State of New Mexico
Energy, Minerals and Natural Resources

WELL API NO. 30-015-02589
5. Indicate Type of Lease STATE [X] FEE []
6. State Oil & Gas Lease No.
7. Lease Name or Unit Agreement Name Daughtery State
8. Well Number #1
9. OGRID Number 154329
10. Pool name or Wildcat Artesia; QN-GRBG-SA
11. Elevation (Show whether DR, RKB, RT, GR, etc.) 3667' GR

SUNDRY NOTICES AND REPORTS ON WELLS
(DO NOT USE THIS FORM FOR PROPOSALS TO DRILL OR TO DEEPEN OR PLUG BACK TO A DIFFERENT RESERVOIR. USE "APPLICATION FOR PERMIT" (FORM C-101) FOR SUCH PROPOSALS.)
1. Type of Well: Oil Well [] Gas Well [] Other []
2. Name of Operator Chisos, LTD. on behalf of Sandlot Energy (Jackie Brewer DBA)
3. Address of Operator PO Box 711 Lovington, NM 88260
4. Well Location
Unit Letter D : 315 feet from the N line and 945 feet from the W line
Section 4 Township 18S Range 28E NMPM County Eddy
11. Elevation (Show whether DR, RKB, RT, GR, etc.) 3667' GR

Action 552192

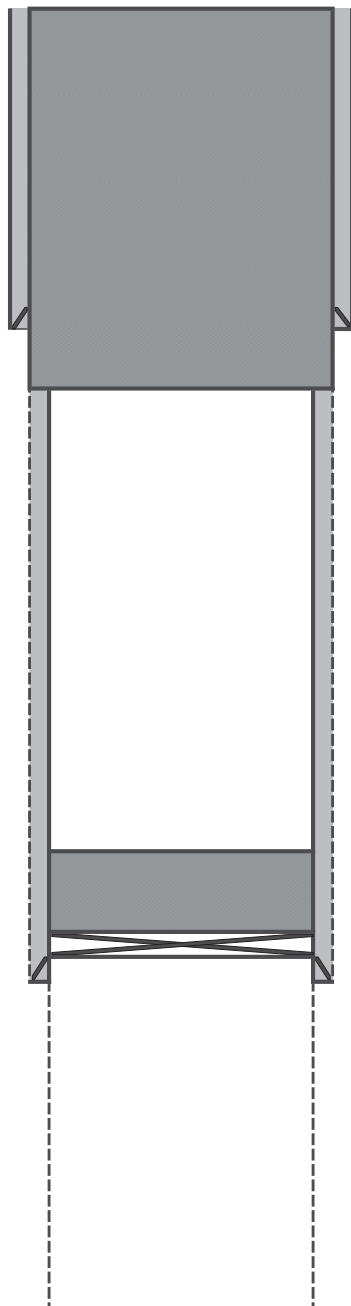
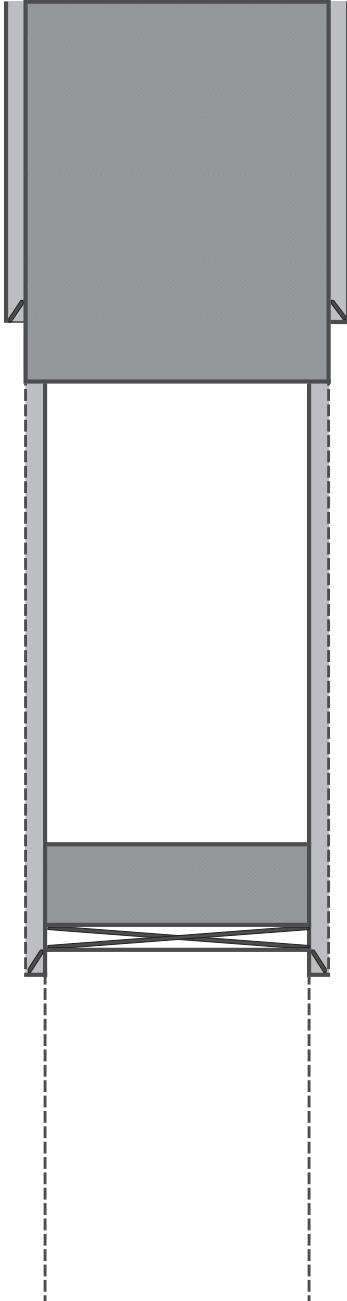
Created By	Condition	Condition Date
loren.diede	Notify the OCD inspection supervisor via email 24 hours prior to beginning Plug & Abandon (P&A) operations.	2/12/2026
loren.diede	NMOCD will review the Gamma Ray log from the CBL to confirm estimated formation tops.	2/12/2026
loren.diede	Submit CBL tif file to NMOCD for upload into the Well Log File.	2/12/2026
loren.diede	NMOCD does not consider this well to be within the LPCH restricted area and an above ground P&A marker is required. Submit photo and GPS coordinates of the P&A marker. The API# on the marker must be clearly legible.	2/12/2026
